Office Action Summary	Application No.	Applicant(s)	9
	10/726,818	FERRELL, JANIS I.	
	Examiner	Art Unit	
	Jon A Szumny	3632

This is the first office action for application number 10/726,818, Tableware Clip-On Device, filed on December 3, 2003.

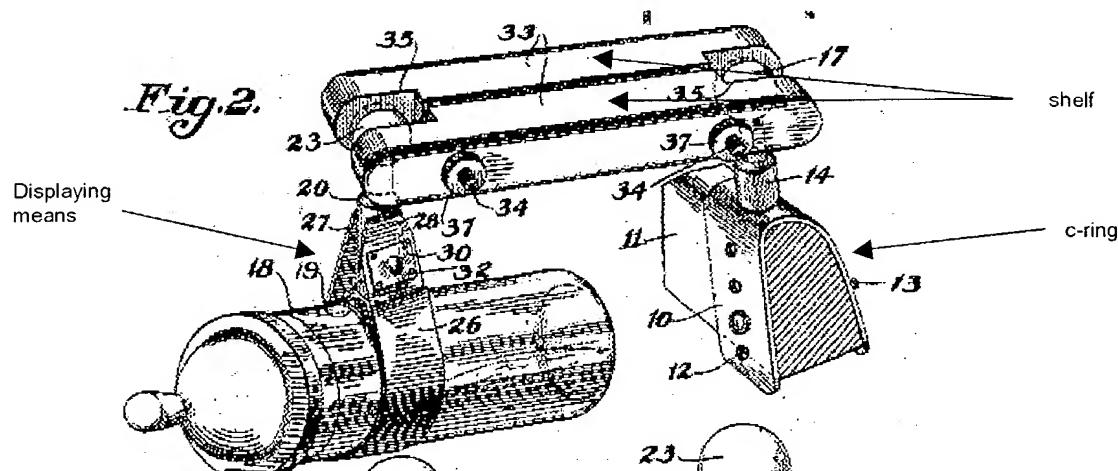
Claims 4-6 are rejected under 35 U.S.C. 102(b) as being anticipated by U.S. Patent number 1,590,227 to Britton.

Britton '227 discloses a clip-on device (above) comprising a c-ring (above) integral with a rearwardly (depending upon a user's specific reference point) extending shaft (15,16, "integral" is defined in Merriam Webster's Collegiate Dictionary - 10th Edition as "formed as a unit with another part," so clearly the ring is integral with the shaft), wherein a distal end of the shaft is connected to a ball (17), a means (36) for movably gripping the ball and supporting a shelf (above), and a displaying means (above), wherein the gripping means is a frictionally engaging partial circular member, wherein the displaying means is a clamping device mounted on the shelf (via 22, 23 and 36).

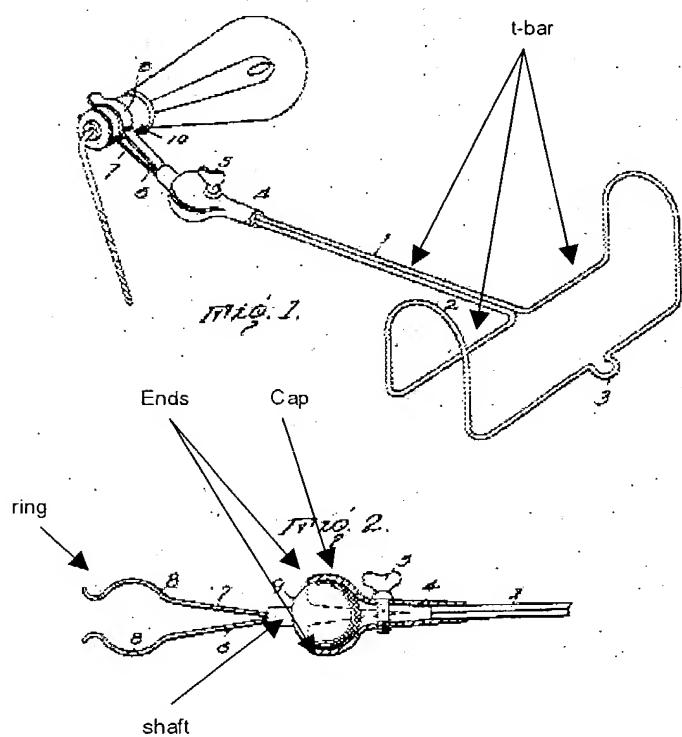
Claim 1 is rejected under 35 U.S.C. 103(a) as being unpatentable over Barnes

'894.

Barnes '894 discloses a clip on device (above) comprising a ring (above) integral with a shaft (above, utilizing same definition of "integral" from above) extending away from a back end of the ring, the shaft connected to a ball (9) at a point distal from the ring, a partially circular cap (above) supporting a t-bar (above) on an exterior surface distal from an opening between a pair of ends (above) on the circular cap, the t-bar supporting a pair of spreadable lips (above, they are inherently "spreadable" since the

wire can be "bent", see lines 42-44), wherein the ring is partially a c-ring, and partially a v-ring. However, Barnes '894 fails to specifically teach the ring to be a c-ring. It would have been obvious to one of ordinary skill in the art at the time the invention was made to have constructed the ring of any of numerous shapes, including a c-shaped ring, so long as it still securely fastens to an object, since the particular shape claimed by the applicant is nothing more than one of numerous shapes that an ordinary artisan provides for using routine experimentation based on its suitability for the intended use of invention. See In Re Daily, 149 USPQ 47 (CCPA 1976).
